SUBJECT: Forwards effluent & waste disposal semiannual rept for
 Jan-June 1986, revised pages to Rev 1 to offsite dose
 calculation manual (ODCM) & entire Rev 2 to ODCM.

SUBJECT: Effluent and Waste Disposal Semiannual Report

H. B. ROBINSON SEG PLANT - UNIT 2

H.B. ROBINSON STEAM ELECTRIC PLANT, UNIT NO. 2
OFF-SITE DOSE CALCULATIONAL MANUAL
(ODCM)

FIGURE 4-2
RADIOLOGICAL SAMPLE
DISTANT LOCATIONS

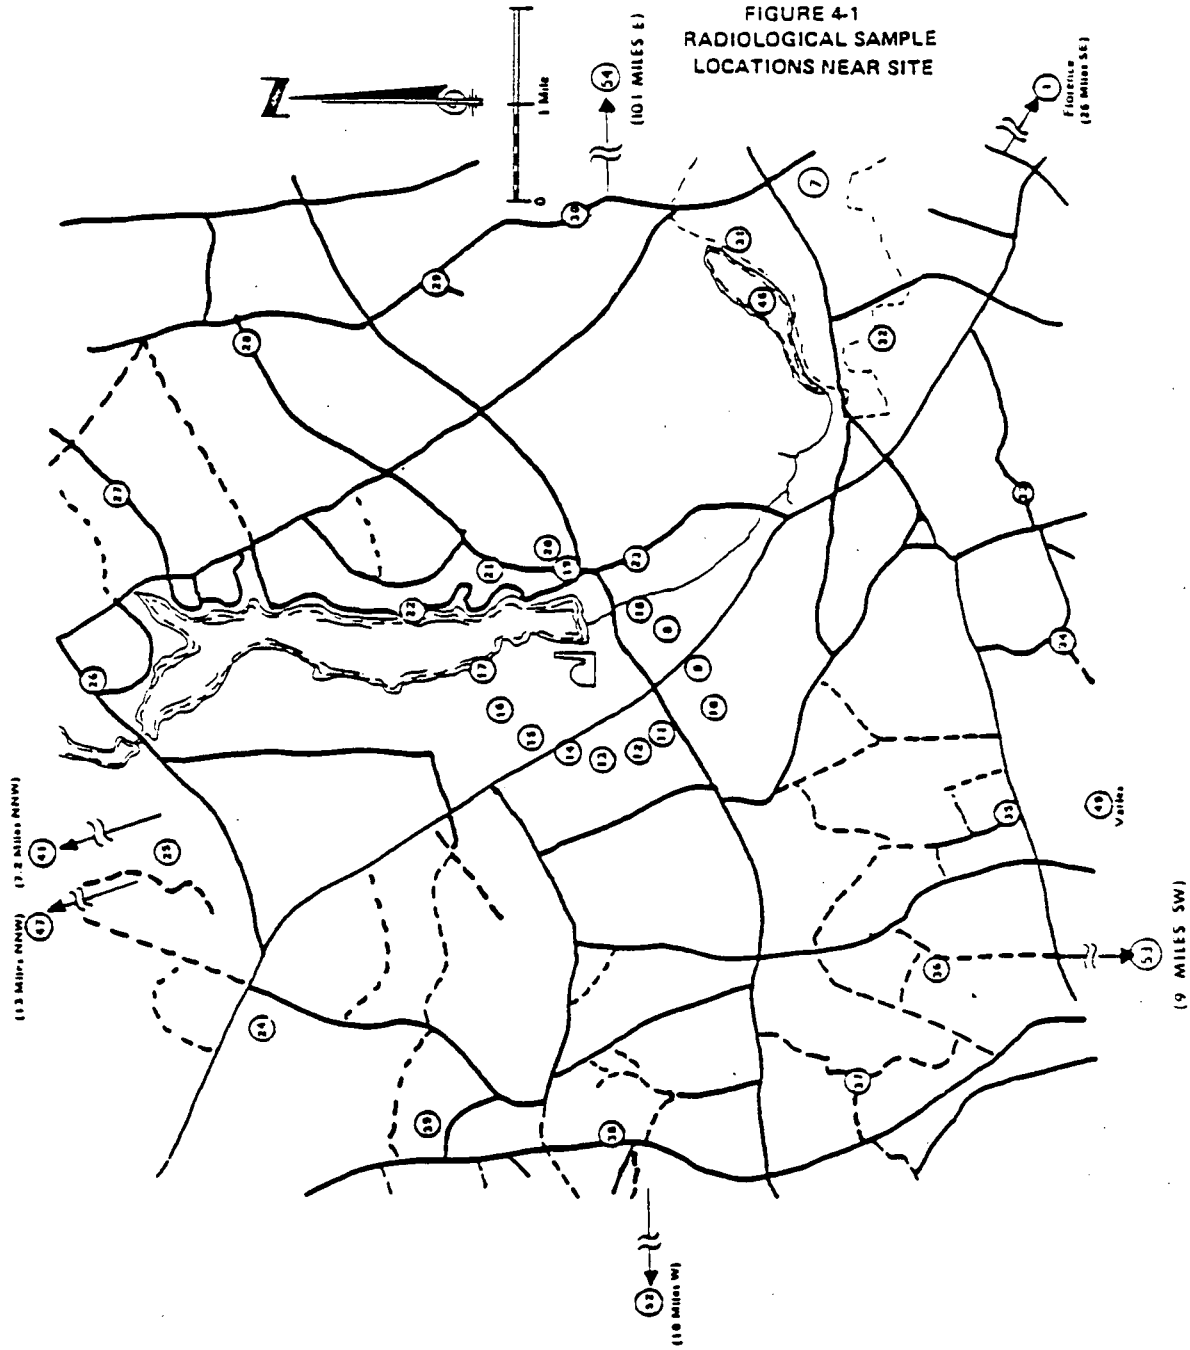
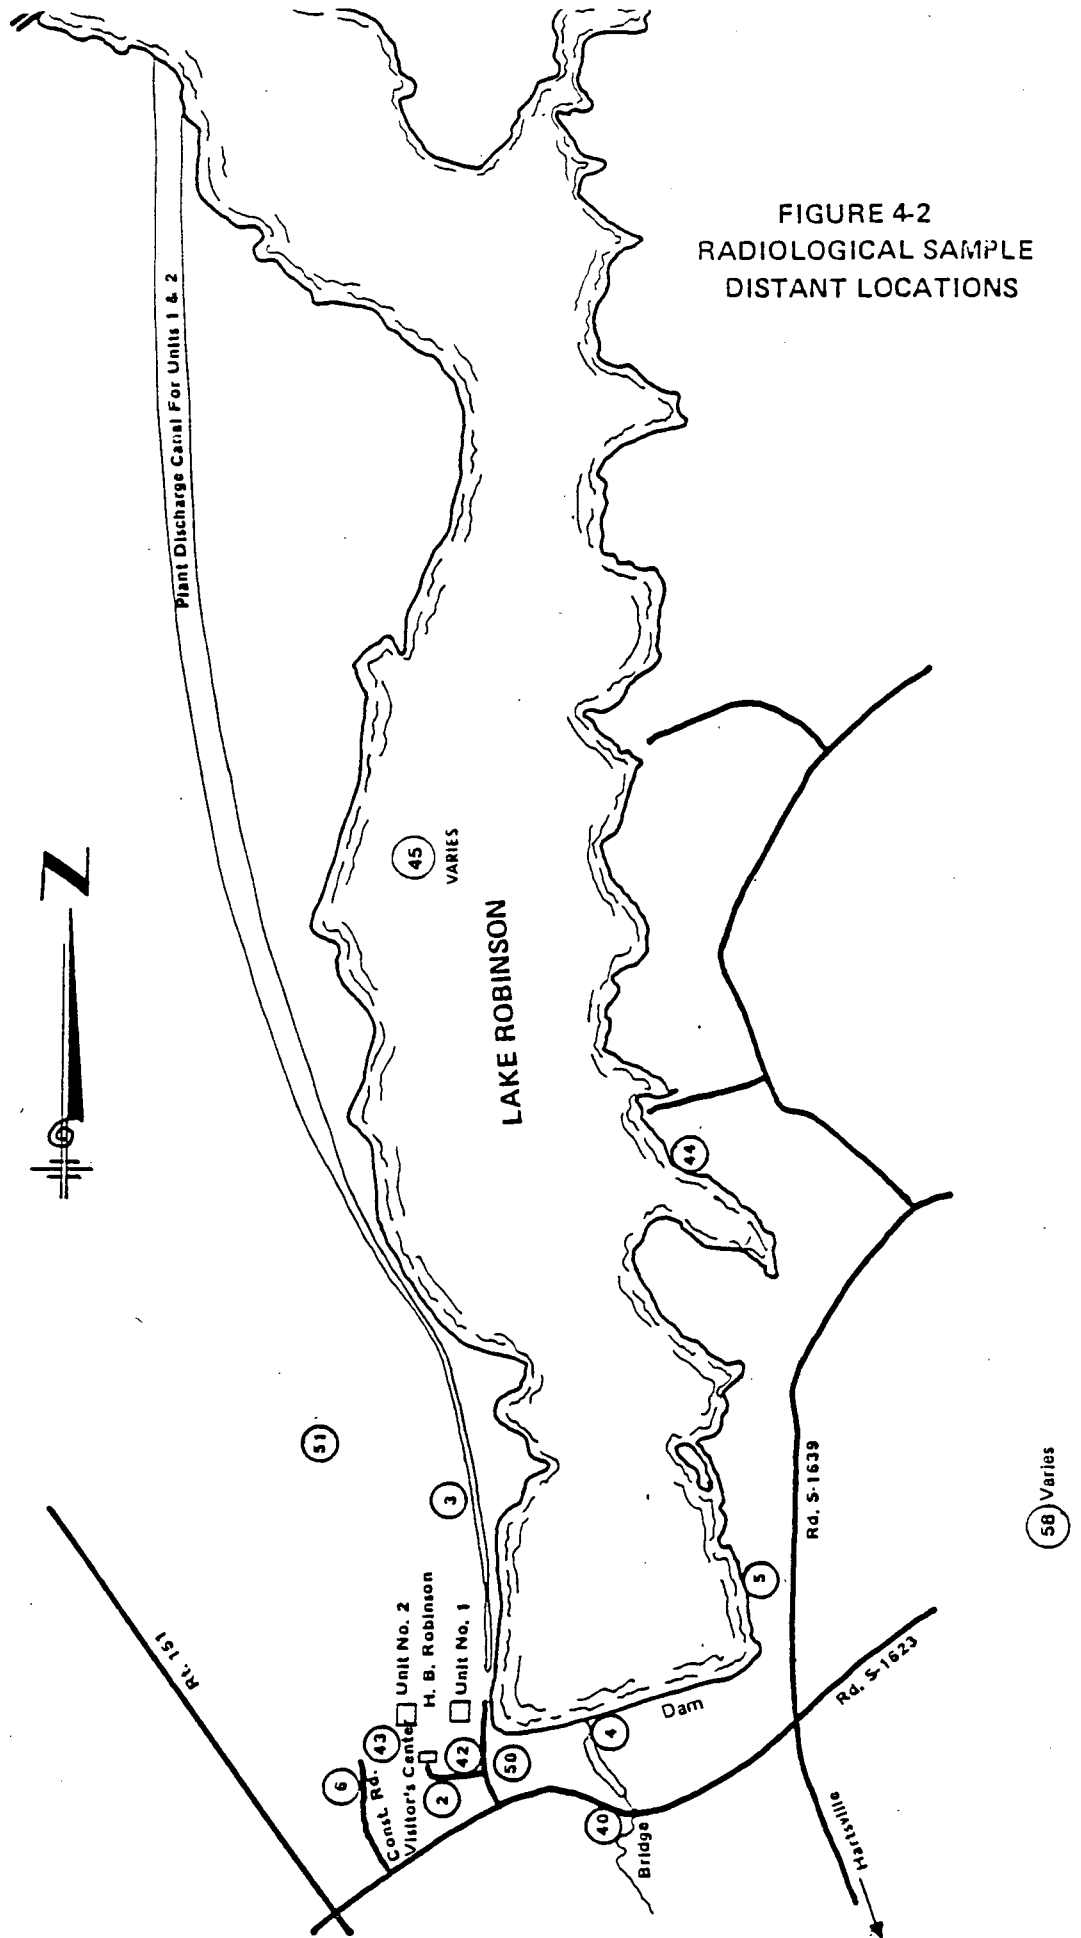
- Page 4-2,
4-3, & 4-9 Editorial added the compass degrees to the first seven sample stations and relocated sample Station 7 one mile further out because the existing location is no longer available for our use. Station 7 also relocated on map on page 4-9.
